#### Memorandum

Date:	August 19, 2015
From:	Marie Ennis, Gabriel Pardo
To:	John Shedd
Company:	Chautauqua Institution
c:	
Project:	Chautauqua Institution Amphitheater Study: Narrative and Questions
Project #:	J3262.02

Chautauqua Institution Amphitheater. **Demo-Construction Sequence**

> Drawing No. S-SEQ-101.00

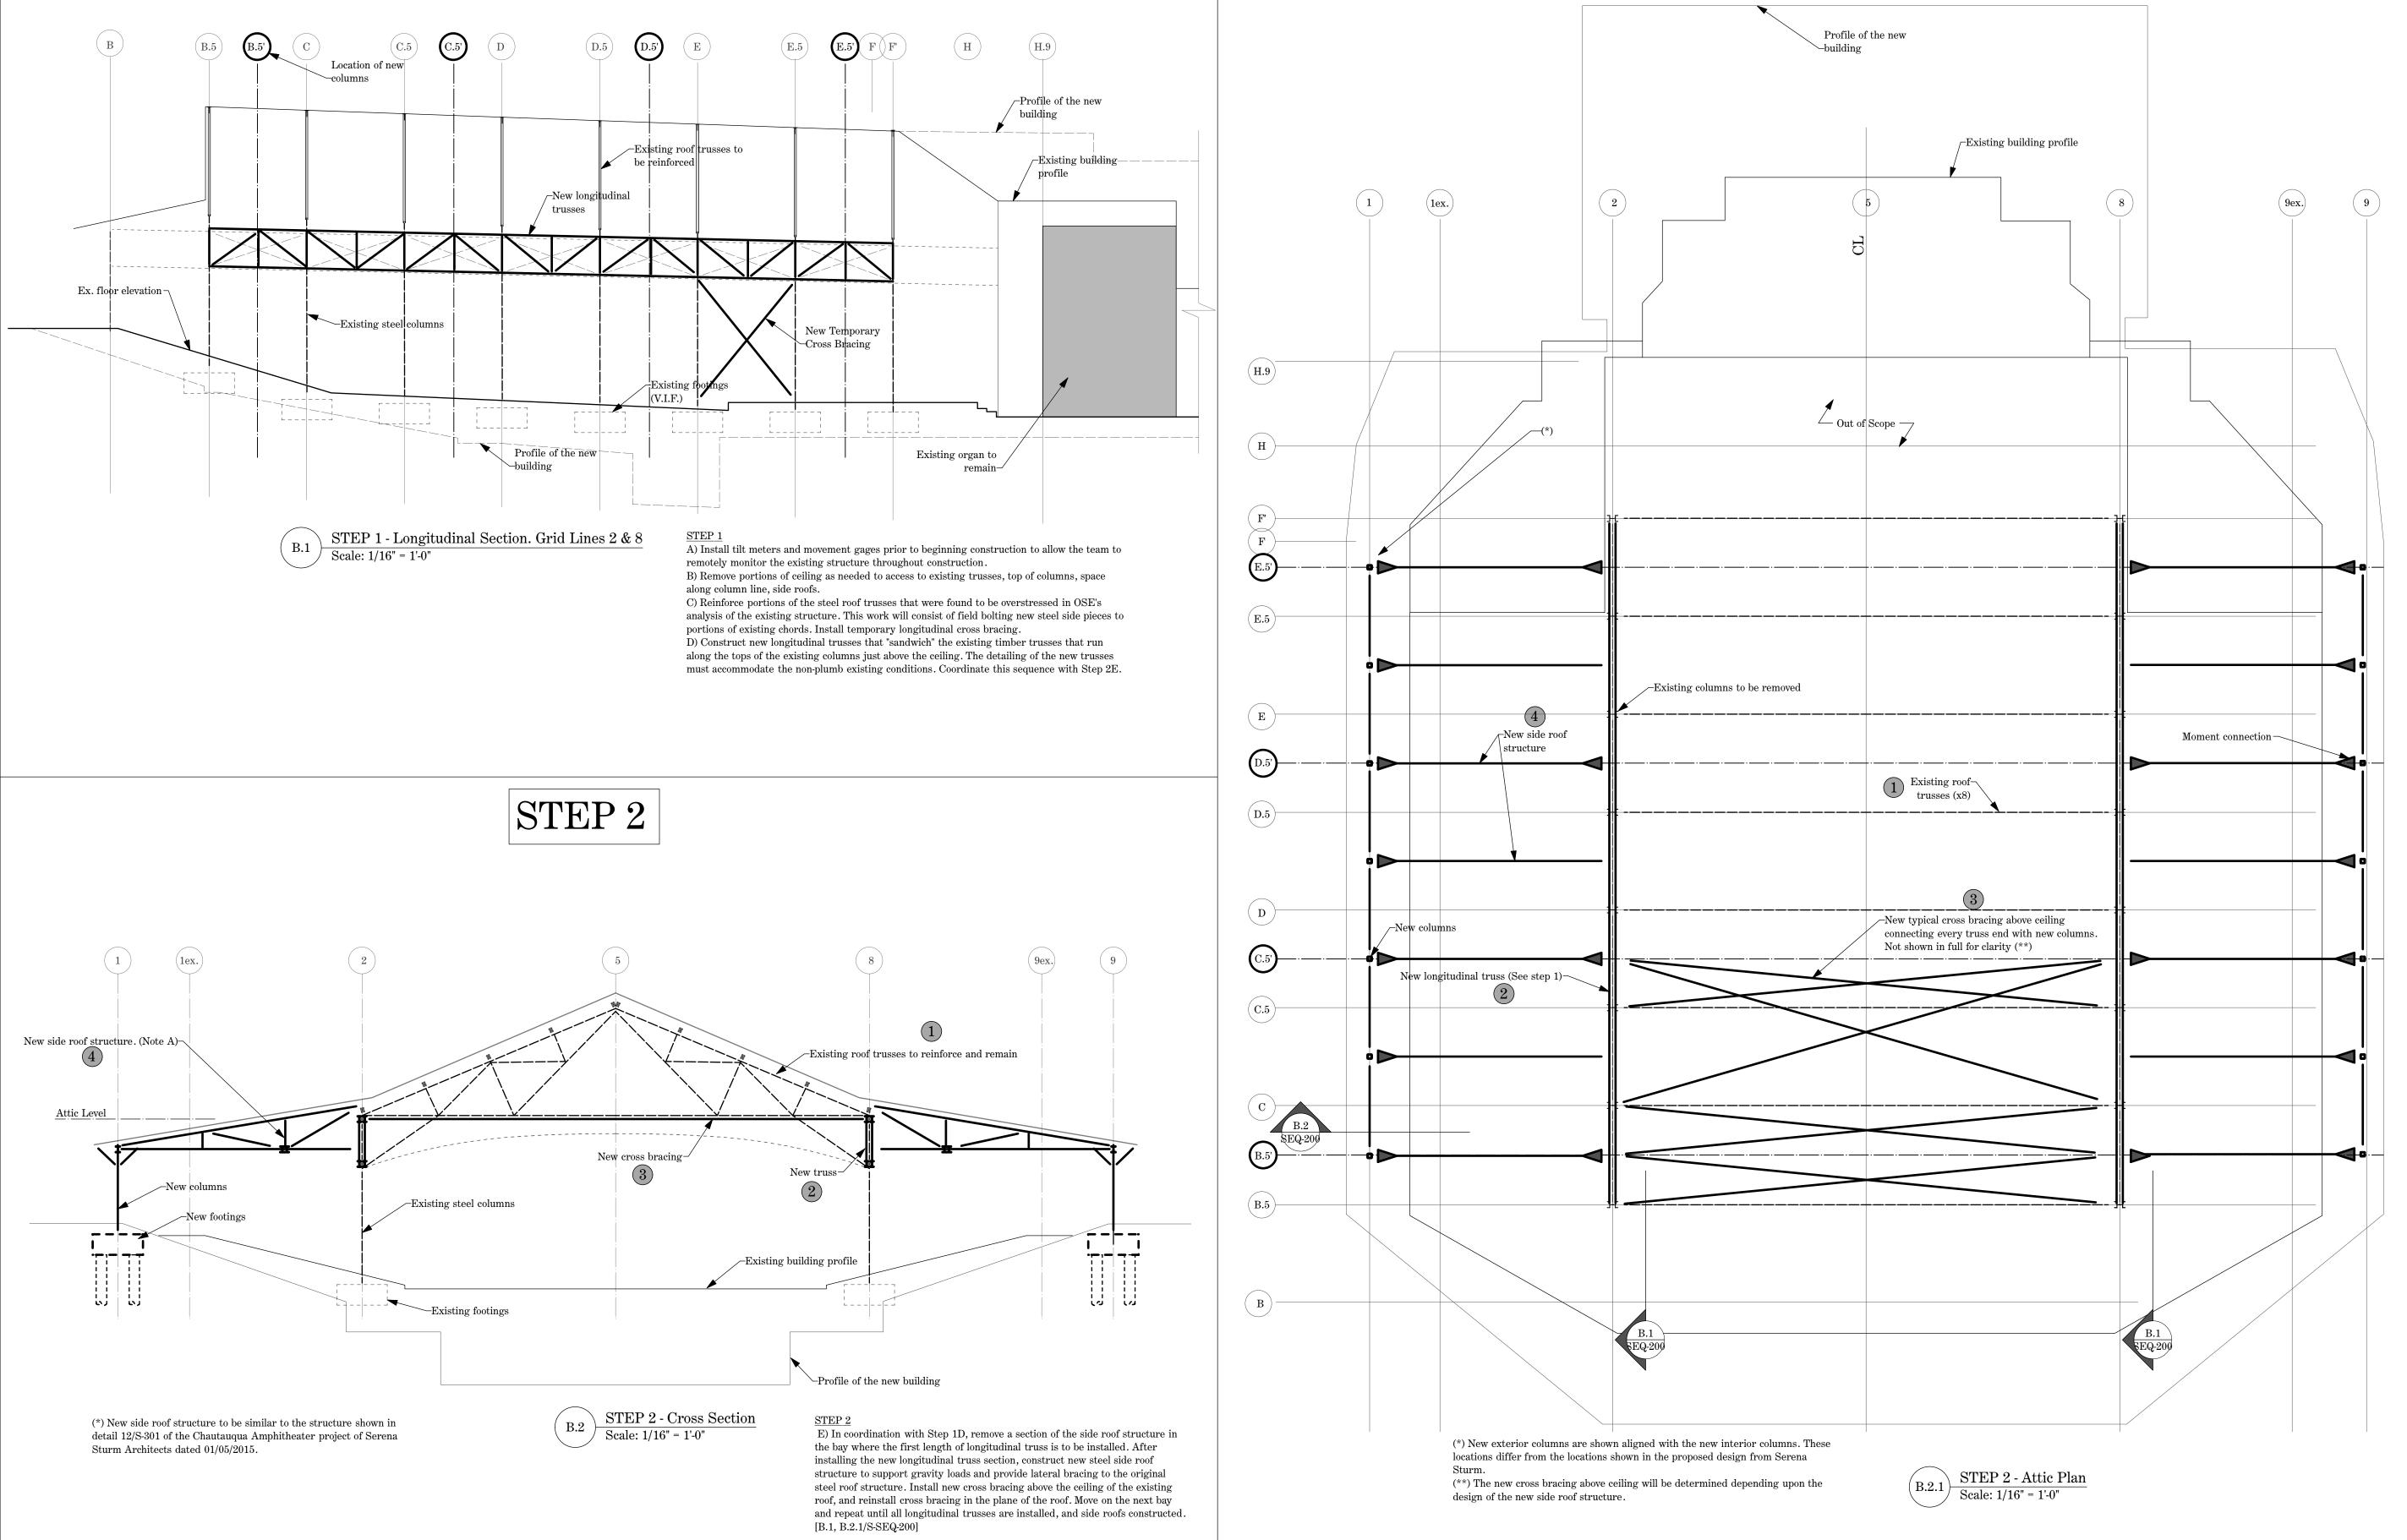
We realize that the helical pile are likely a place holder for some sort of deep foundation system, but we suggest that the helical piles be revised to micro piles as it is atypical to use a helical pile to bear on top of bed rock. Also, it is unlikely to be able to drive helical piles through fragmented/weathered rock to get proper bearing on sound bedrock.

Step 4 likely creates a stability issue if helical piles are used (i.e. to unbraced length of helical pile vs. overturning moment capacity). Again, we recommend that micro piles, socketed into sound bedrock be used in lieu of helical piles.

It is likely that the column by column approach as well as the need to be re-locating the temporary bracing would have a negative impact on the schedule. During the DD phase

Note A: "Longitudinal truss shall be connected to new east end building to provide lateral stability". It is not clear if the modifications presented in Option A create a selfsupporting structure or if the structure transfers loads into the "New Building" as shown as Out of Scope. Due to the limited amount of space that the "New Building" occupies, it is unlikely that the new building will be able to support any magnitude of lateral load.

Yes, the helical piles are a place holder. We agree that micro-piles or mini-caissons can bear on, or be socketed into, rock as needed. The drawings have been revised to eliminate reference to helical piles.

See response to Step 3 comment.

OSE looked at the feasibility of saving the roof, not cost and schedule.

Although OSE did not review the new building design, we believe that any load transfer between front-of-house/back-of-house could be accommodated, for example, with shear walls or braced frames, moment frames. A seismic gap may or may not be required, depending on the seismic analysis of the existing building. Given the relative lightness of the roof structure, we believe it is possible that the wind and uneven snow loads govern (which means no separation required). Either way, the existing structure can be detailed to be completely independent of back-of-house structure as needed.

> Drawing No. S-SEQ-200.00

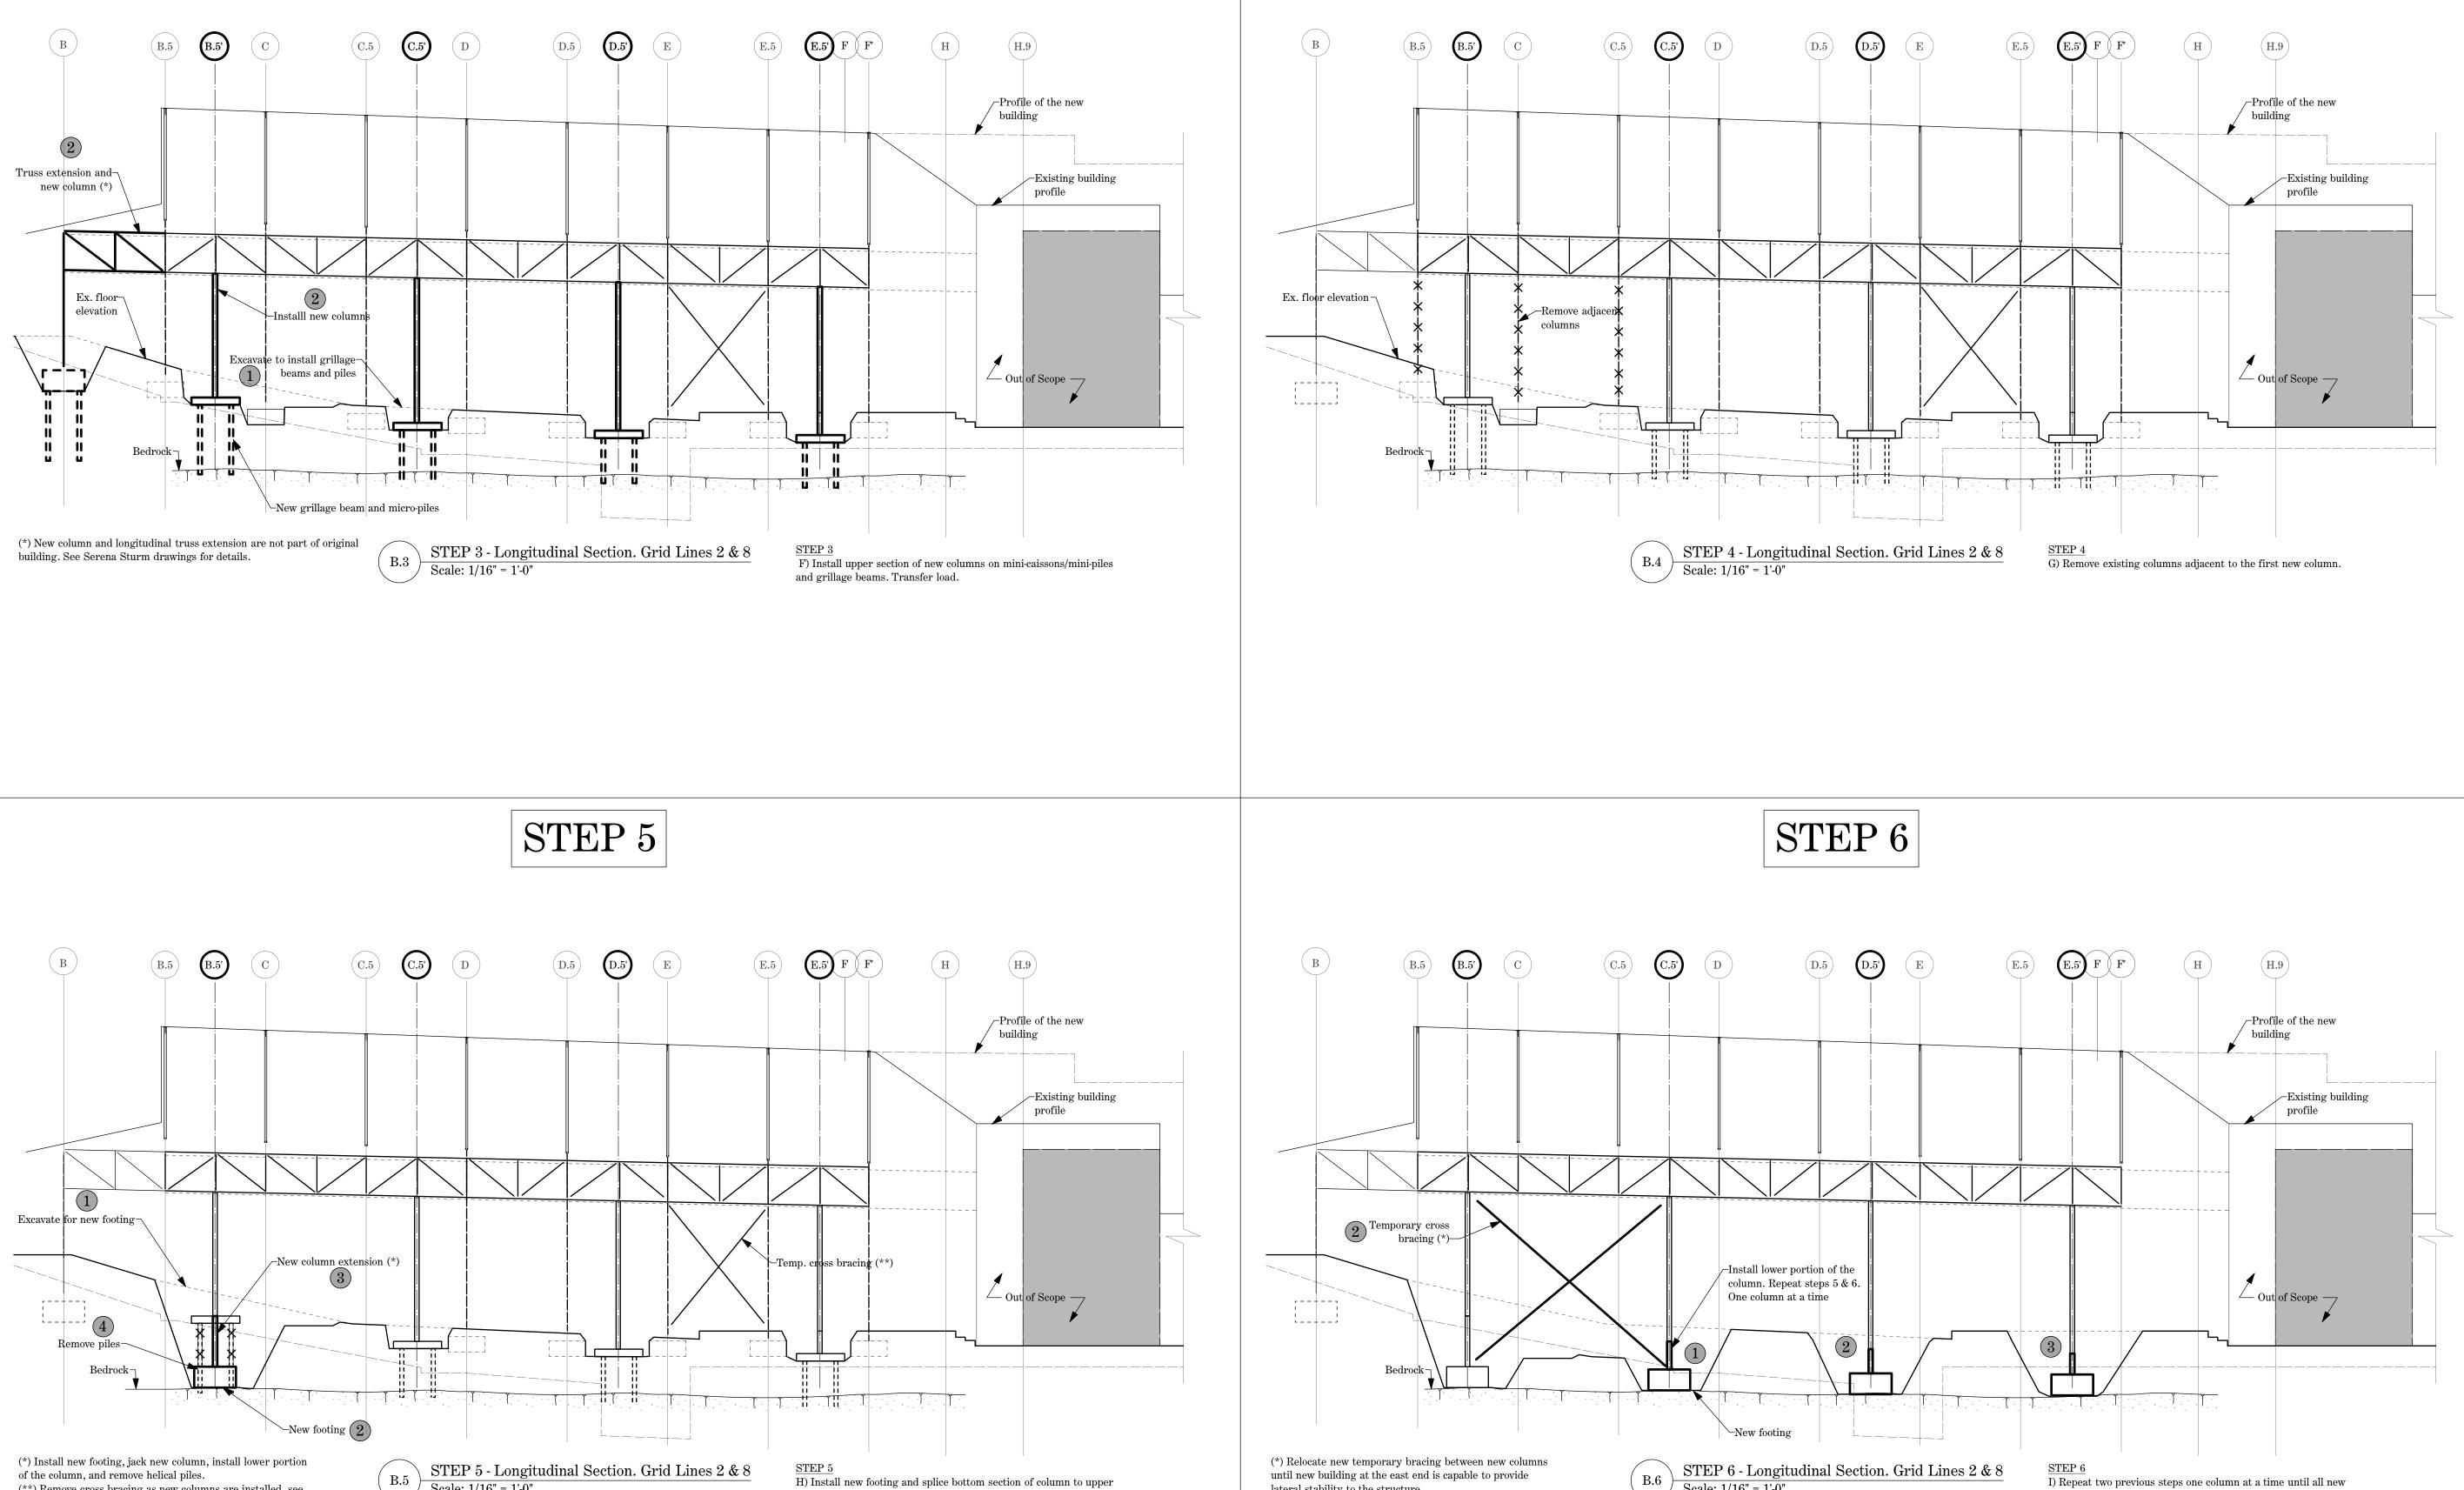
The existing trusses/columns are not uniformly spaced, therefore fabrication and fitment of the new longitudinal trusses will be difficult, and field re-work is likely needed.

The report does not address the removal or shoring/temporary support of the existing "side roof" trusses. To facilitate the installation of the new outboard longitudinal truss, the existing "side roof" trusses must be removed in their entirety or temporarily supported and have enough material removed to facilitate the installation of the new longitudinal truss.

The installation of the new cross bracing above the ceiling will likely be difficult to do physically in place, and will likely require that the existing ceiling material be removed.

See Option A Step 1.

See Option A Step 2.

> Drawing No. S-SEQ-201.00

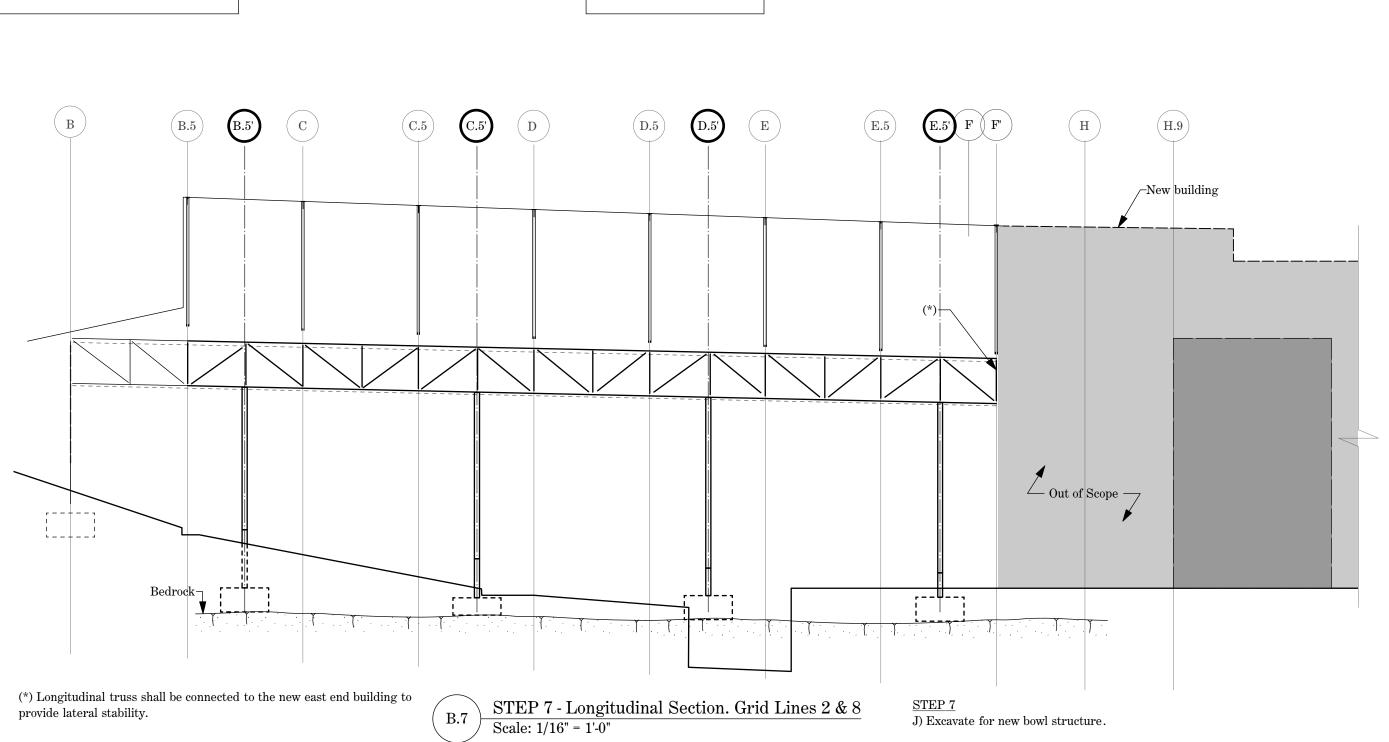
We realize that the helical pile are likely a place holder for some sort of deep foundation system, but we suggest that the helical piles be revised to micro piles as it is atypical to use a helical pile to bear on top of bed rock. Also, it is unlikely to be able to drive helical piles through fragmented/weathered rock to get proper bearing on sound bedrock.

Option B places new columns at the mid bay location between the existing columns. The design team was tasked with keeping the remaining columns at existing column locations. Moving the new columns as shown would likely create a need for wholesale changes to the bowl design and seating configuration.

We realize that the helical pile are likely a place holder for some sort of deep foundation system, but we suggest that the helical piles be revised to micro piles as it is atypical to use a helical pile to bear on top of bed rock. Also, it is unlikely to be able to drive helical piles through fragmented/weathered rock to get proper bearing on sound bedrock.

Option B appears that it would improve the schedule over Option A as all foundations/columns can be installed at the same time, vs. the step by step approach as shown in Option A.

Step 5 likely creates a stability issue if helical piles are used (i.e. to unbraced length of helical pile vs. overturning moment capacity). Again, we recommend that micro piles, socketed into sound bedrock be used in lieu of helical piles.

See Option A Step 3.

The general notes on S-SEQ-001 state that not all of the design goals for the full demolition/new building could be accommodated and keep the main roof in place, therefore other non-structural aspects of the design would need to be revised accordingly. Step 4:We agree that Option B has some advantages over Option A.Step 5:Resolved by using micro-piles or mini-caissons.Steps 6 & 7:See Option A Step 6.
